# ECQ method

(comment R2-205 and others)

# Comment R2-205

**Figure 180–10—Illustration of the TDECQ measurement**

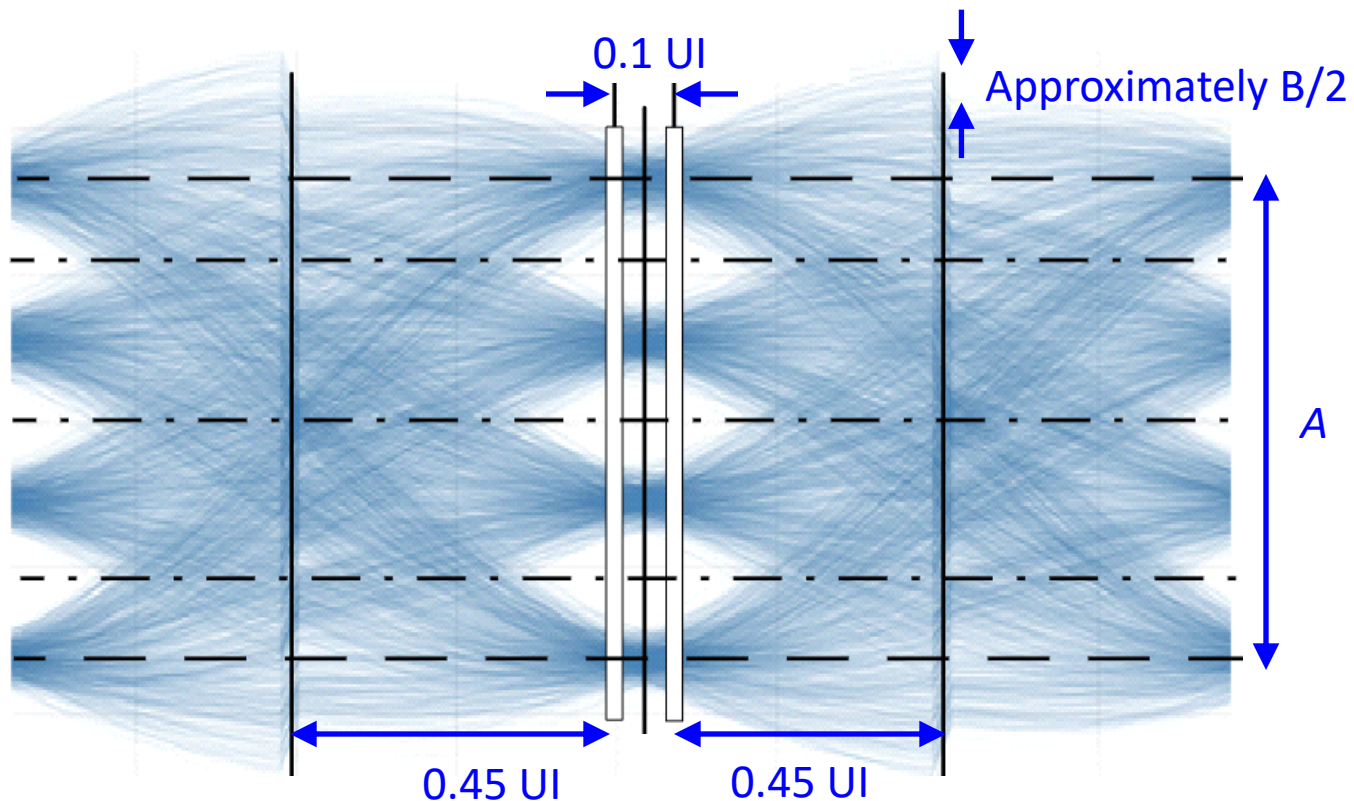
- If available, replace the graphic with one with the correct histogram window widths, transparent histogram windows, without the three vertical lines, and with the feedback transitions at  $180^\circ$  from the histograms
- No need to label the horizontal lines, which could be left out too
